RTL8102EL/8103EL/8111DL Circuit

Rev. 1.06

PAGE INDEX

Realtek Semiconductor Corp.			
Title RTL8102EL/8103EL/8111DL circuit: POWER			
Size A3	Document Number RTL8102EL_106.DSN		Rev 1.0
Date:	Thursday, September 25, 2008	Sheet	2 of 8

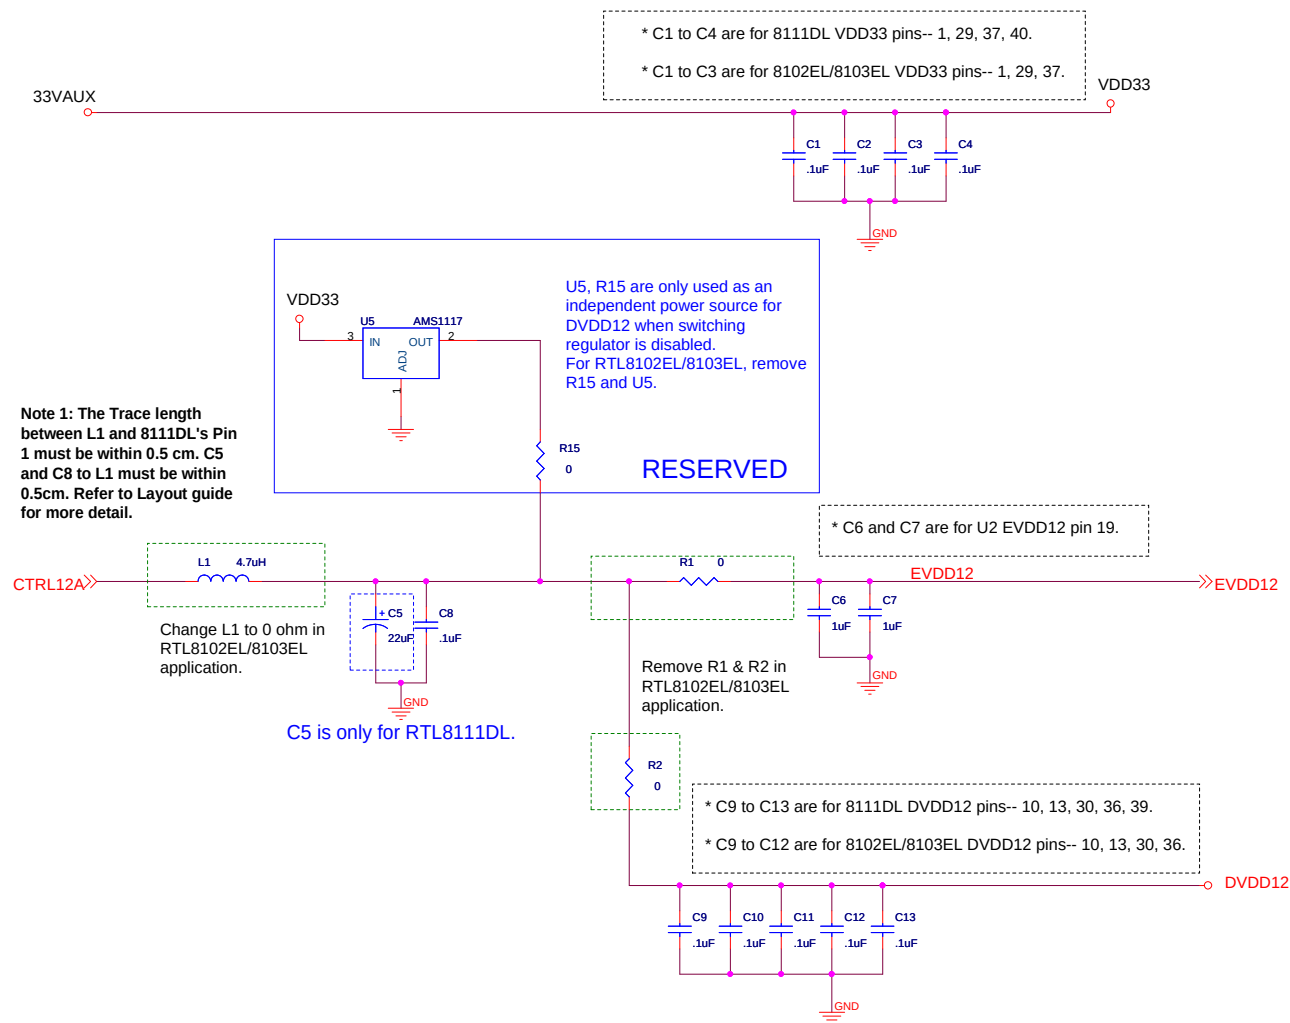
1. Add reserved circuit for independent 1.2V source. (Page 2)
2. Update comment about R5 and R6. (Page 3)
3. Update RTL8111DL BOM list. (Page 3)
4. Add RTL8103EL circuit and BOM List.

1. Update RTL8102EL, 8103EL, 8111DL BOM List.
2. Add comment about C6 for 8111DL application. (Page 2)
3. Add comment about R13. (Page 3)

1. Update 8102EL, 8103EL BOM List.
2. Modify C4 comment for the 8102EL/8103EL application. (Page 2)
3. Modify R5 and R6 comment for the 8111DL application. (Page 3)
4. Add optional ESD protection array circuit for the 8111DL application. (Page 3)
5. Add DSM reference circuit page. (Page 4)

1. Change C7 from 0.1uF to 1uF for RTL8102EL, RTL8103EL and RTL8111DL. (Page 2)
2. Update 8102EL, 8103EL and RTL8111DL BOM List.
3. Modify comment about R13 for RTL8103EL. (Page 3)

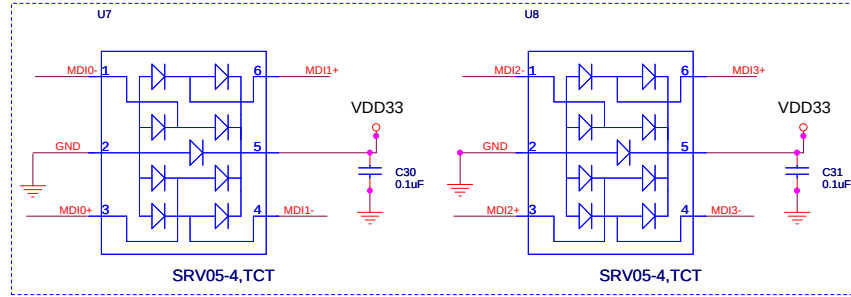
1. Change R13 from 10K to 1K (Page 3)
2. Update ESD Protection array reference part to SRV05-4, TCT. (Page 3).

U7 and U8 are ESD protection array. Reserve for cable discharge.
